ANIMO

|	
ComBi-Line NG Software versions	
Date: May 2023

LIVE
Combi-Line NG software V1.06 (release date April 2023)

− **BOILER START UP AUTOMATIC** (Default = OFF)

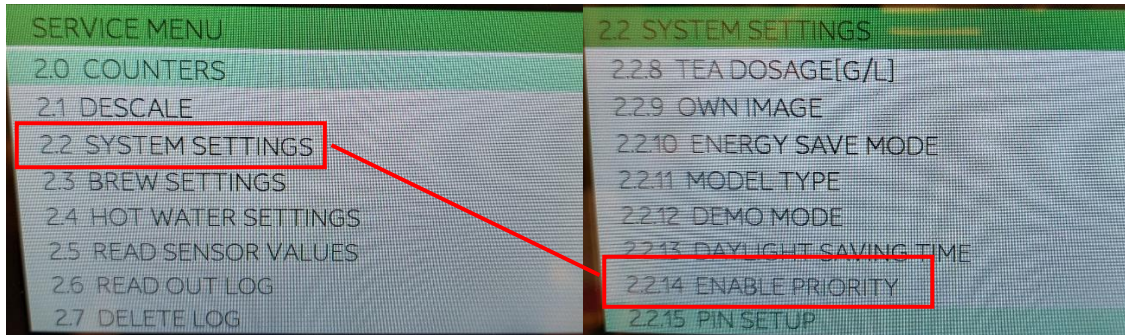
[Service menu / 2.4 Hot water settings / 2.4.5 Boiler start-up automatic]

- ON = Hot water boiler <u>automatically active</u> (ON) when machine is switched ON with the main switch.
- OFF = Hot water boiler <u>must be activated by hand</u> when machine is switched ON with the main switch.

– **HEATING PRIORITY** (Default = ON)

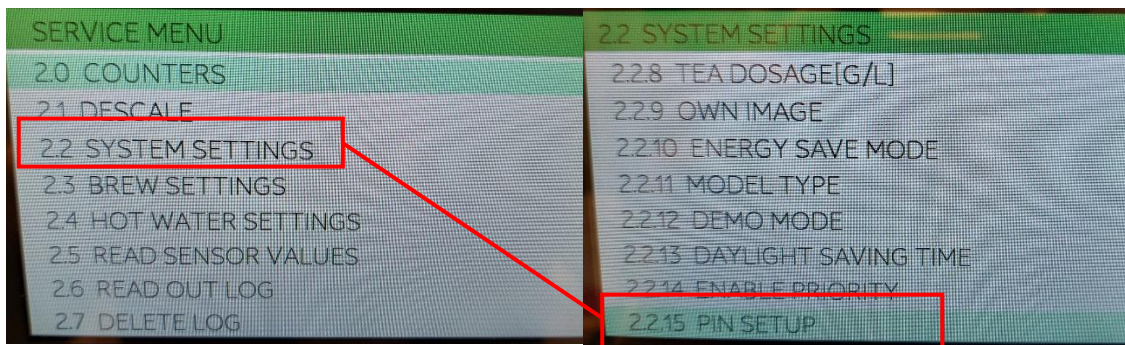
[Service menu / 2.2 System settings / 2.2.14 Enable priority]

- ON = Flow heater has priority above Hot water boiler heater (low Amps)
- OFF = Flow heater & Hot water boiler heat together (Attention: High Amps, check cable and plug spec's)
